**Rockingham Phases 2 & 3, Modelling of Amended Proposed Roundabout.
Our Ref: 18005**

This letter has been prepared to quantify the impact of increasing the size of the roundabout on the operational efficiency of the proposed roundabout as requested by Barnsley Highways Officers.

Drawing Title
SECTION 278
ROUNDAABOUT LAYOUT

4652-2 - JPG - SK001

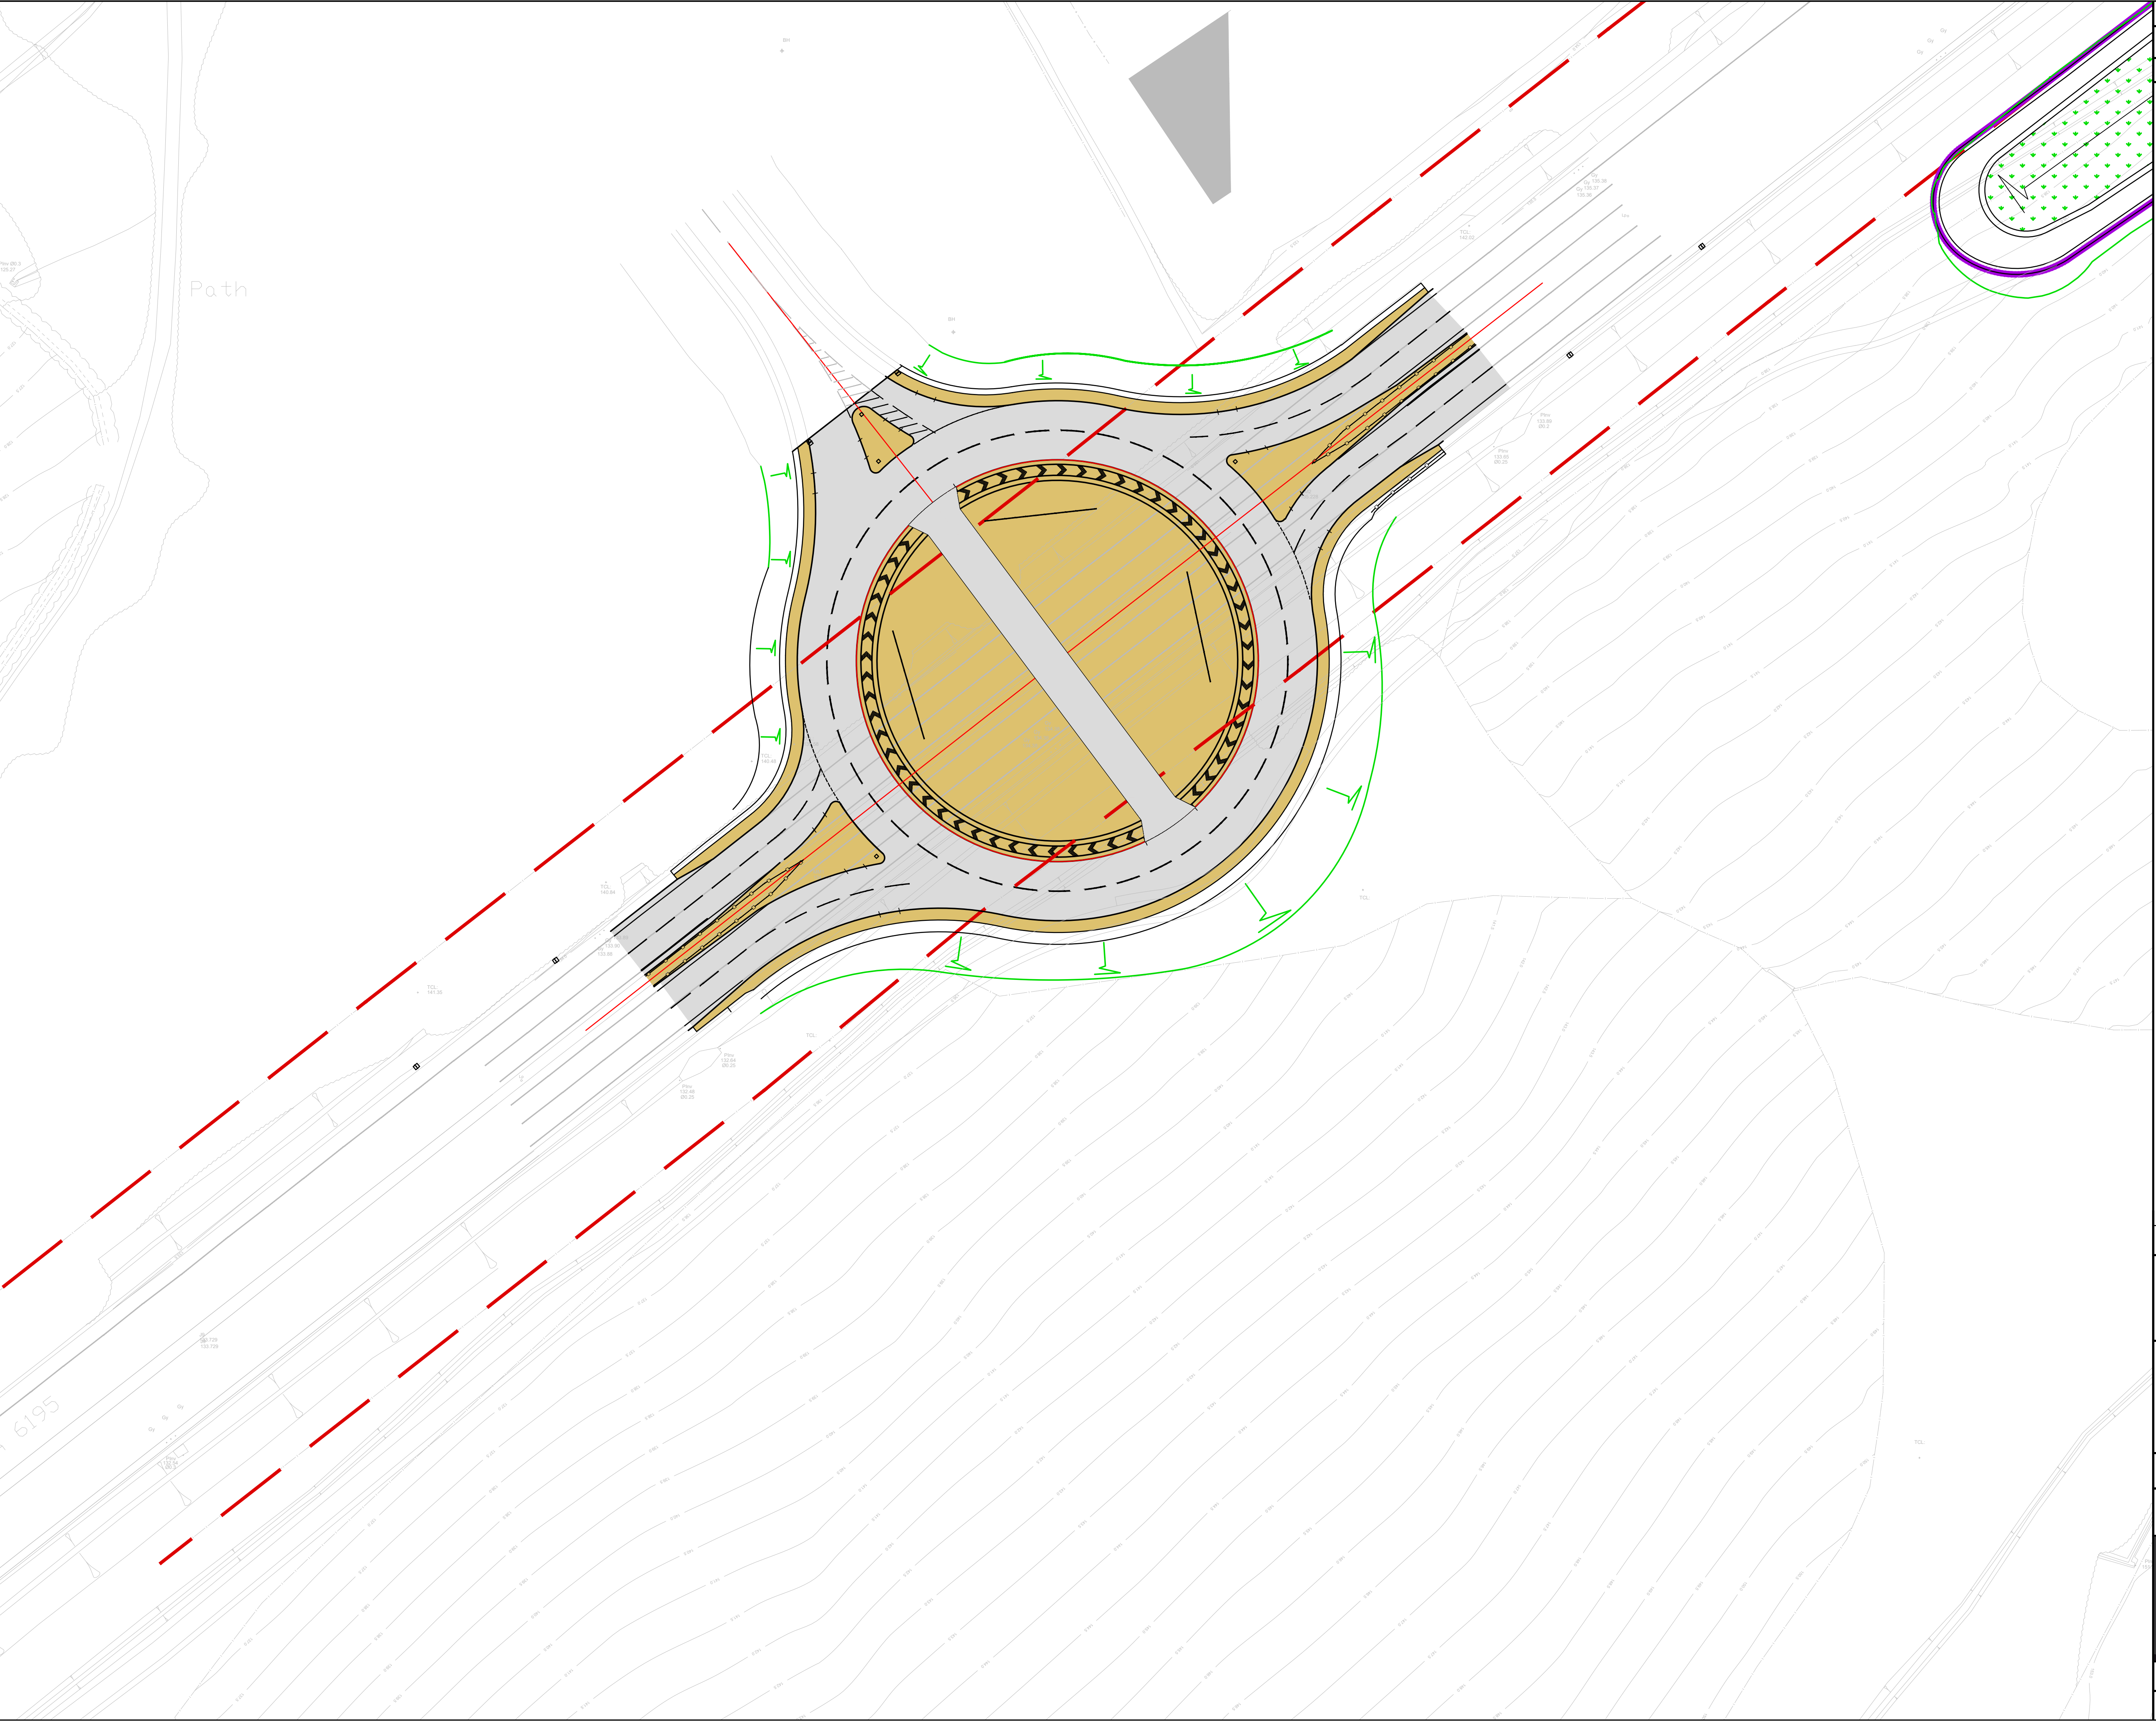
Tables 1 and 2 below show the modelling outputs from the original roundabout layout as shown in the Transport Assessment (TA) issued by Mosodi and the revised roundabout layout respectively (see enclosed drawing).

As is shown in the tables above, it can be seen that the amendments to the scale of the roundabout have resulted in negligible changes in the operational efficiency of the roundabout.

The increase in the diameter has increased the deflection and reduced the entry radius. This results in a very minor worsening of the operation of the roundabout.

However, it should be noted that the junction operates comfortably within desired thresholds with an RFC of under 0.85 (indication that the junction will operate within its predicted capacity) and a negligible impact on geometric delay.

To provide comfort that there is no impact on the strategic model we have compared the predicted delays going through the roundabout between the outputs shown in the TA (Table 1) and the revised model (Table 2) with increased scale, please see the enclosed documentation.

As is shown in the summary tables the delay on the A6195 South/North in the 2029 PM Design Sensitivity scenario is 4/3 seconds in Table 1 (TA Model), this increases to 6/4 seconds in the revised design shown in Table 2.

This increase is derived from the 15 minute peak window within the hourly peak, making it the worst case scenario. The addition of a 2 second delay will have no material impact on the operation of the junction and will not increase journey times within the Strategic Road Network.

The delay is geometric delay due to the slowing of vehicles as they approach the junction and not related to capacity.

I trust the content of this letter and the enclosures provide the comfort that the proposed revised junction will continue to operate comfortable within capacity in the worst case peak hour period.
